**PP201/2012-3**

**15 Karingal Drive WYE RIVER**

**Construction of a Single Dwelling & Removal  
of Two (2) Trees**

# Application to AMEND a Planning Permit

proposed dwelling  
15 Karingal Drive, Wye River  
town planning  
B. Pursehouse

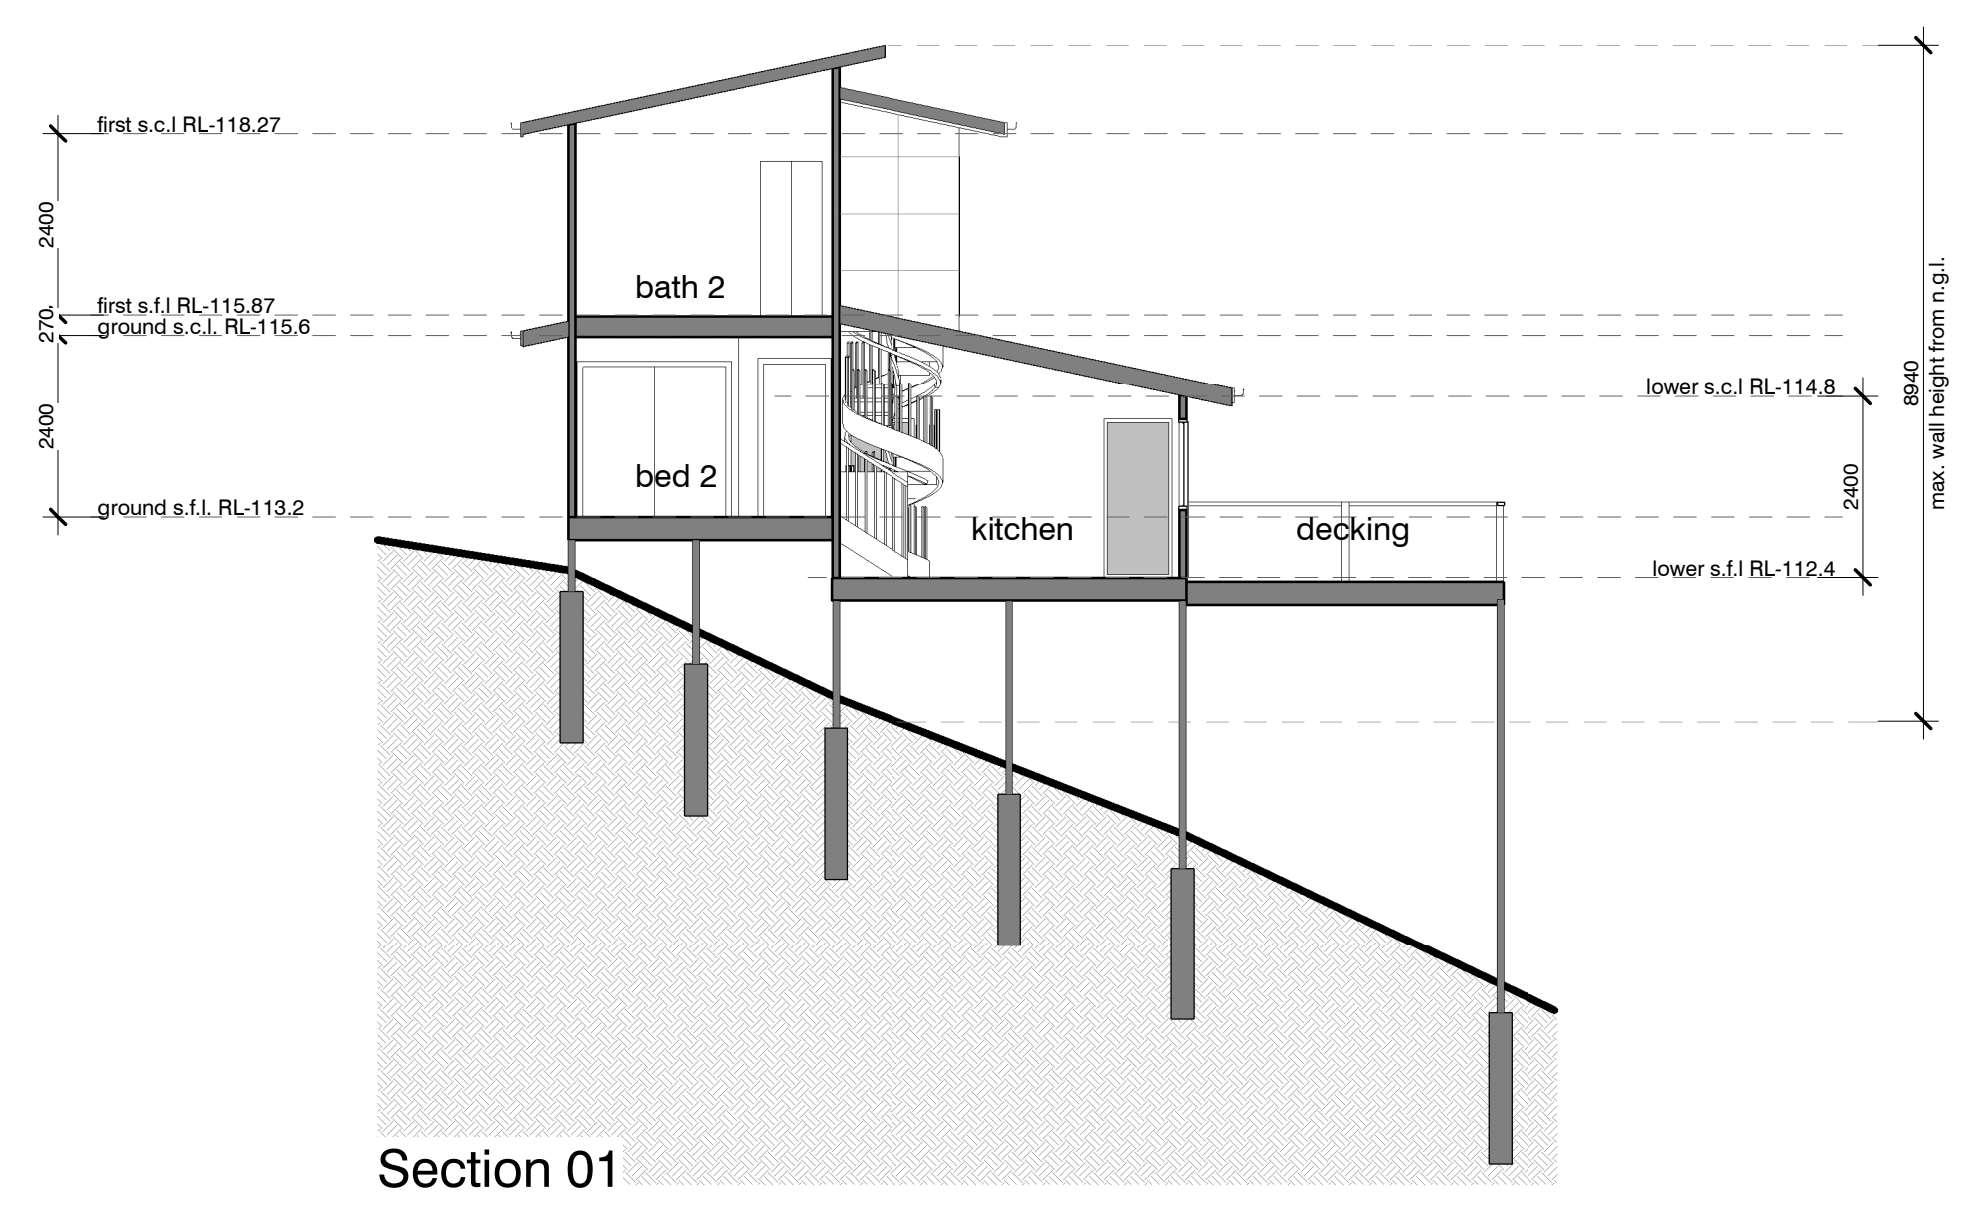
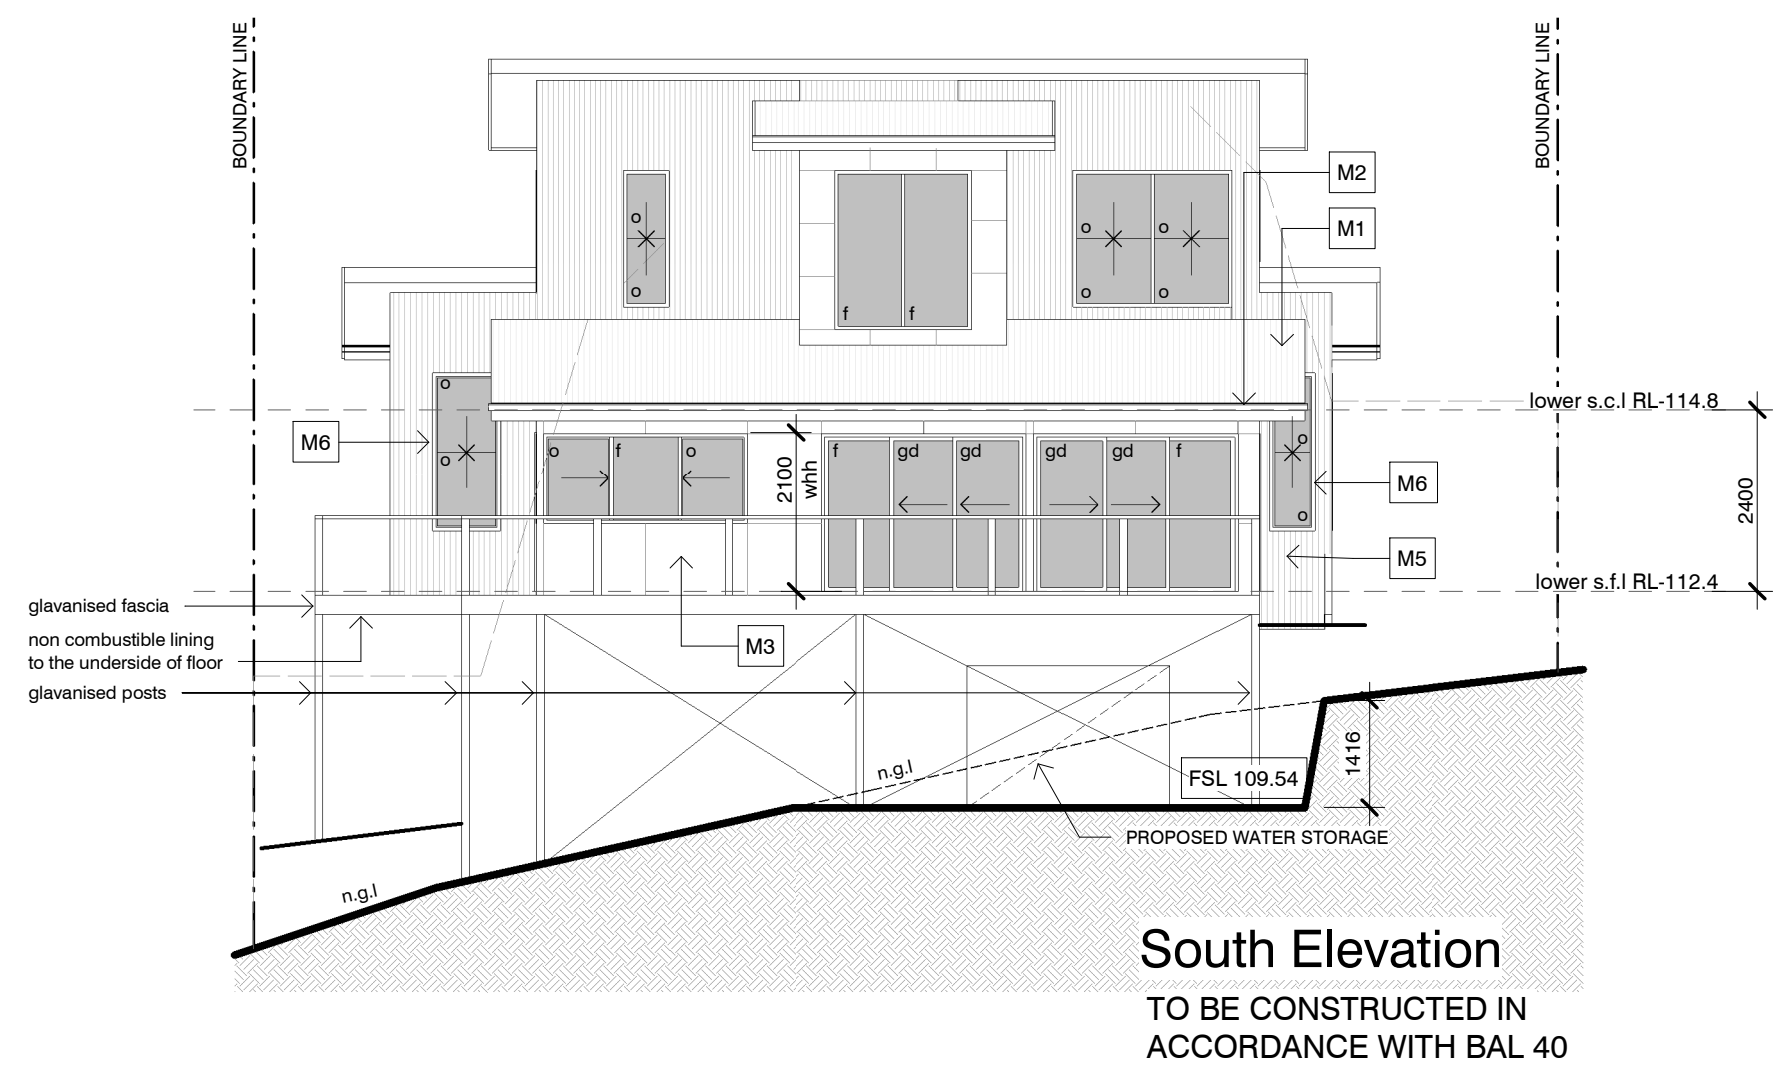
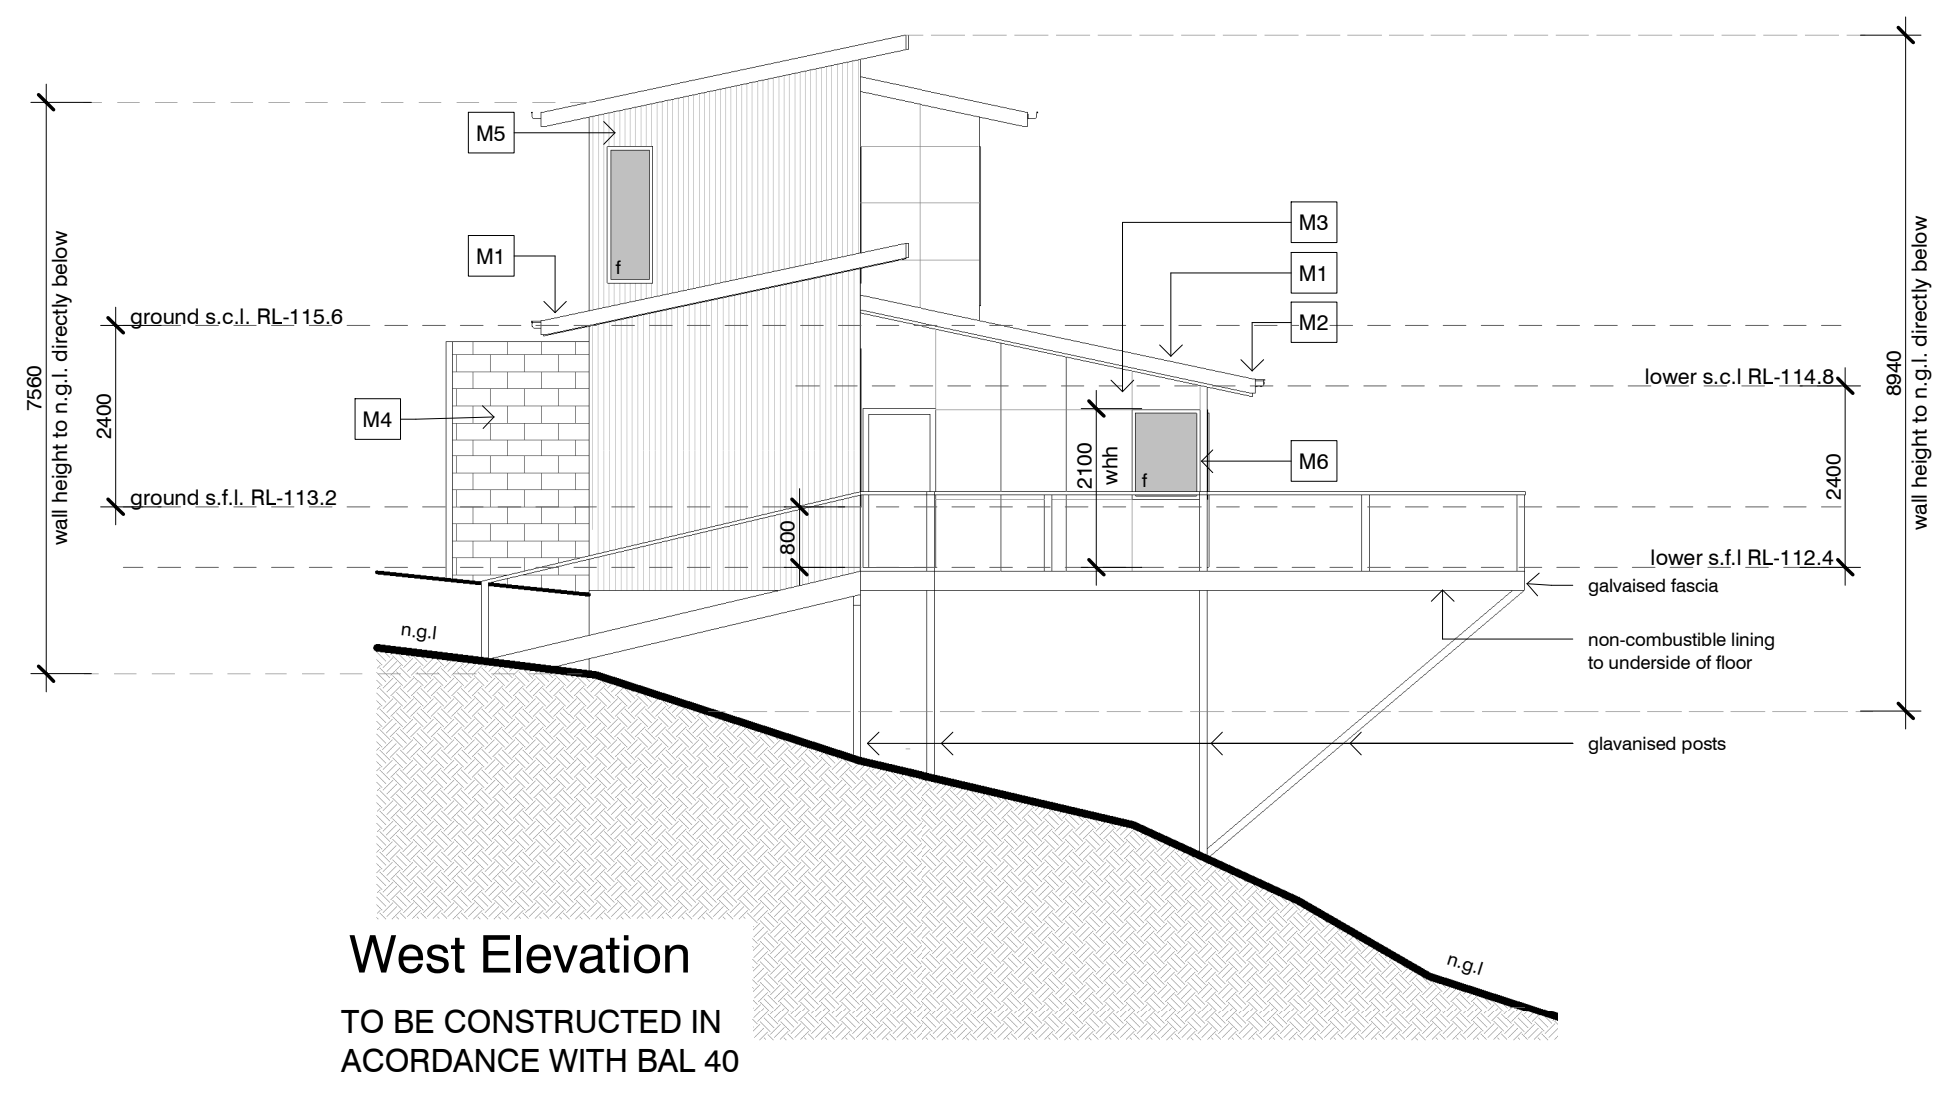
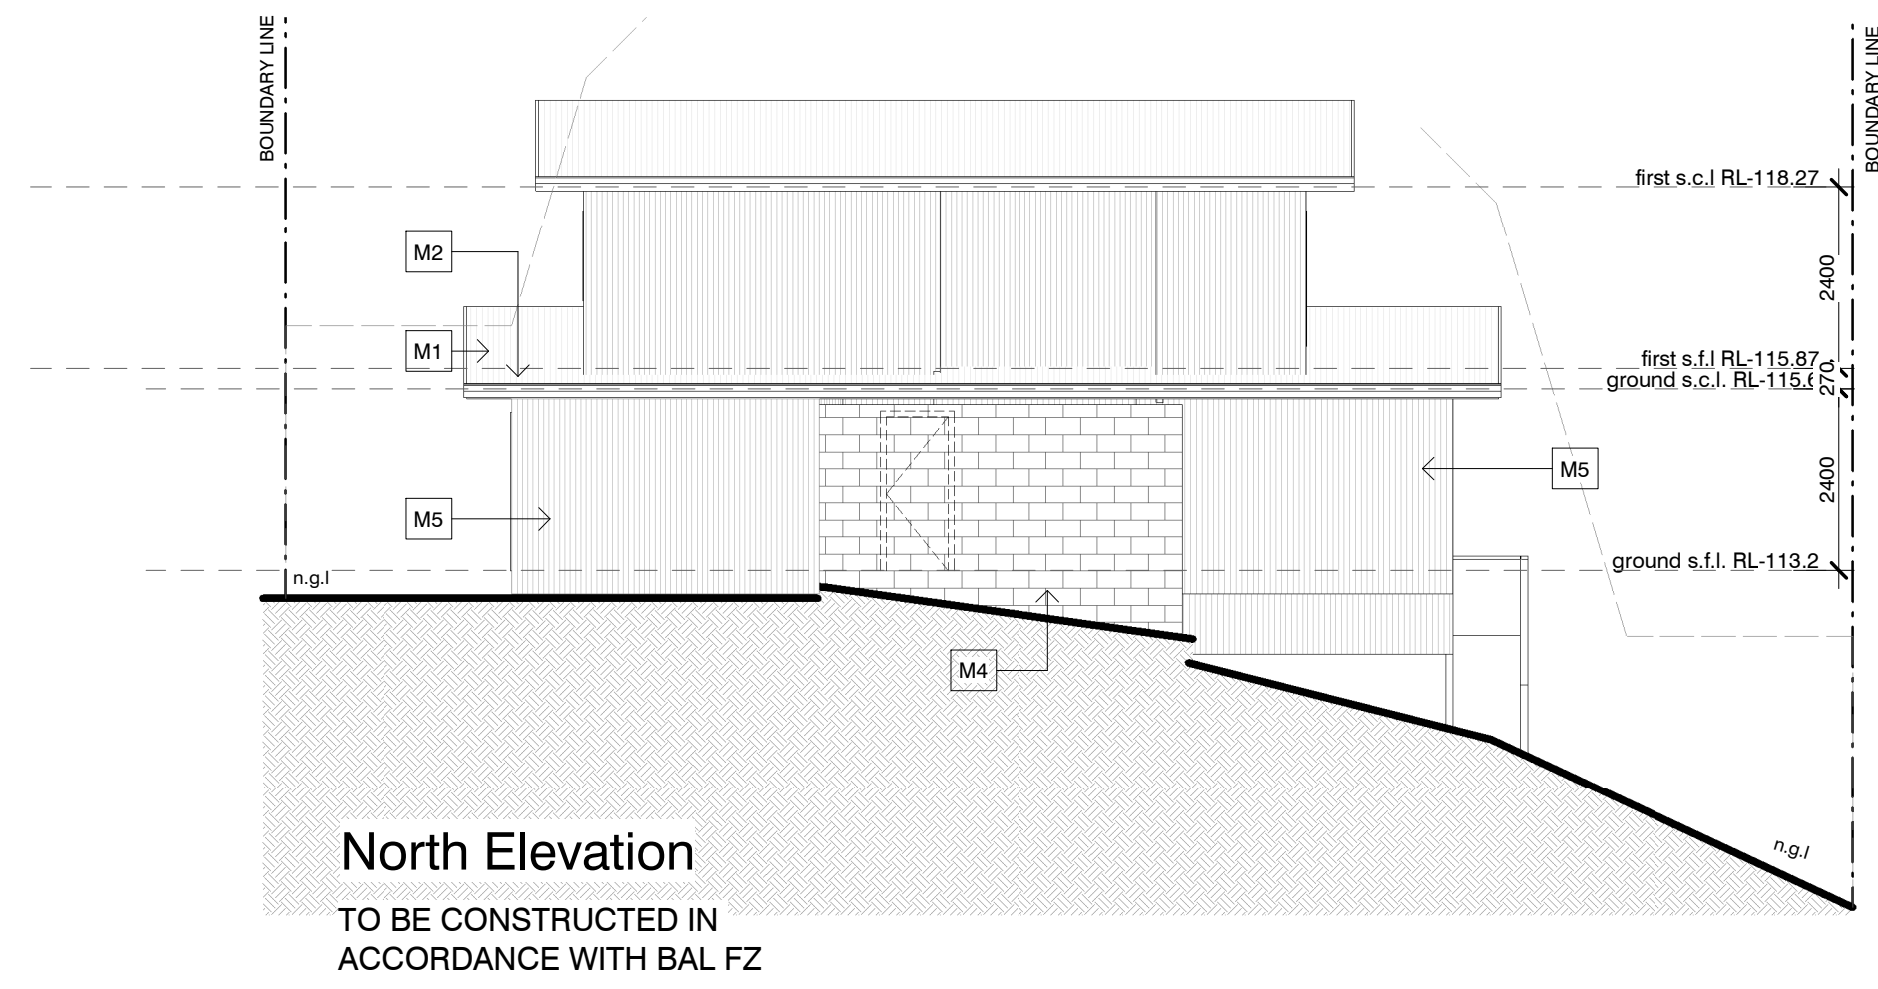
Rev G: Add First Floor 25.01.19  
Rev F: TP F1 07.05.18 Council Change  
Rev E: TP F1 04.05.18 Council Change  
Rev D: TP F1 02.05.18 Council Change  
revision: Rev C: TP F1 17.04.18 Bath Layout Change  
revision: Rev B: TP F1 21.03.18
